| Job   | Truss | Truss Type  | Qty | Ply | DCI Dialysis Clinic |
| 19129 | J02   | Jack-Closed | 2   | 1   |                     |

Star Truss/Star Lumber & Supply, Wichita, Kansas

**EMC STRUCTURAL ENGINEERS, P.C.**

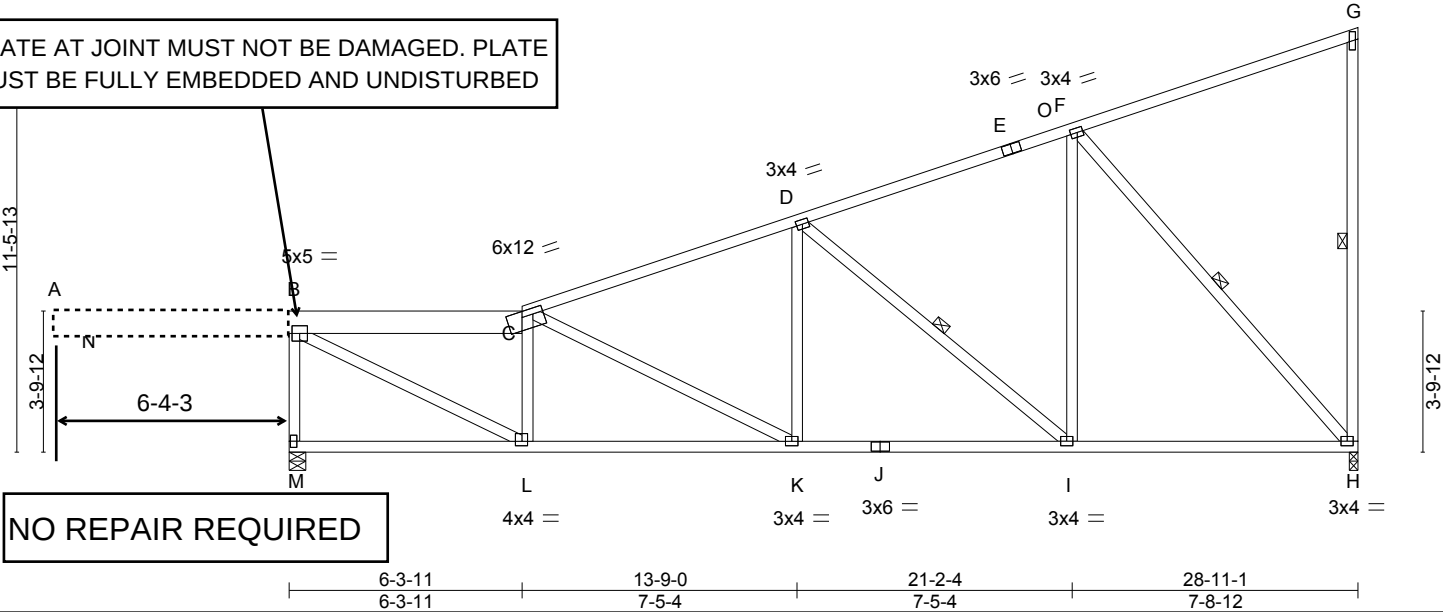
ALTERATION DETAIL:

- CUT AND REMOVE TOP CHORD OVERHANG ON LEFT END OF TRUSS AS SHOWN.

PLATE AT JOINT MUST NOT BE DAMAGED. PLATE

MUST BE FULLY EMBEDDED AND UNDISTURBED

| 19129 | T31   | Roof Special | 2   | 1   | Job Reference (optional) |

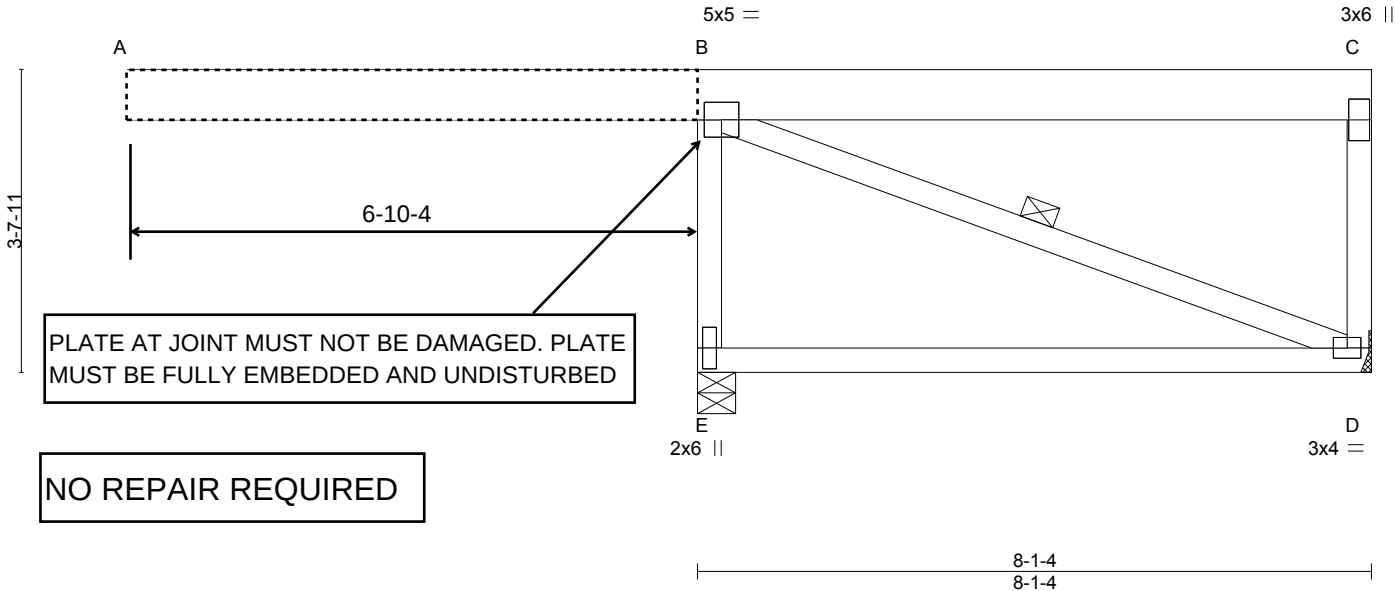
ALTERATION DETAIL:

- CUT AND REMOVE TOP CHORD OVERHANG ON LEFT END OF TRUSS AS SHOWN.

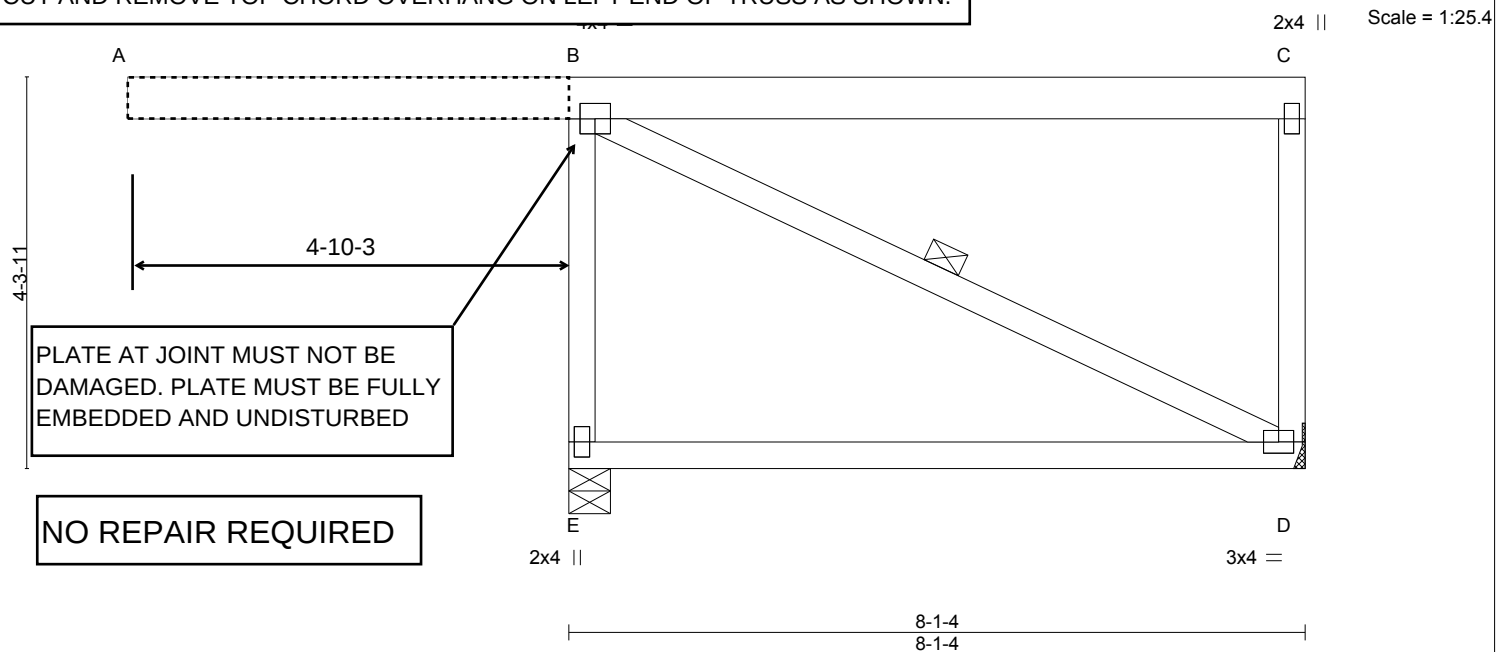
#### ALTERATION DETAIL:

- CUT AND REMOVE TOP CHORD OVERHANG ON LEFT END OF TRUSS AS SHOWN.

| 19129 | T33   | Roof Special | 2   | 1   |                     |

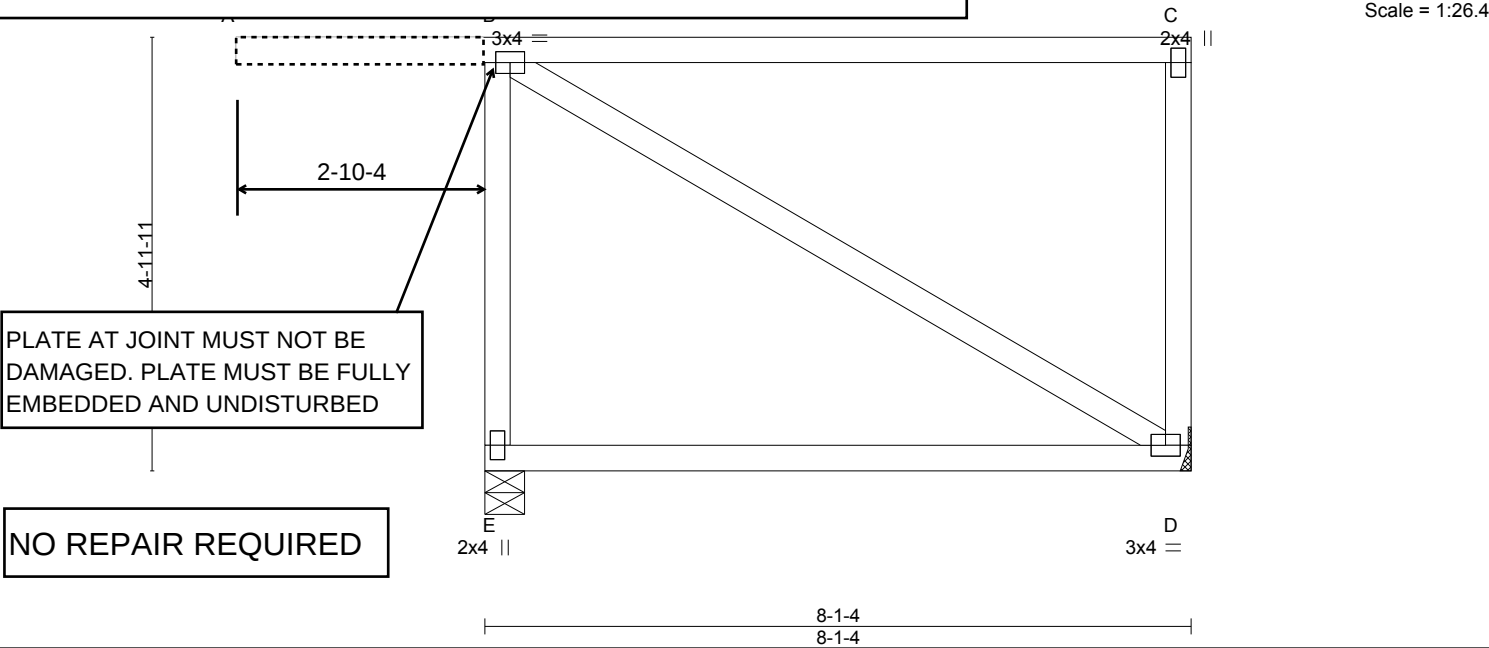
ALTERATION DETAIL:

- CUT AND REMOVE TOP CHORD OVERHANG ON LEFT END OF TRUSS AS SHOWN.
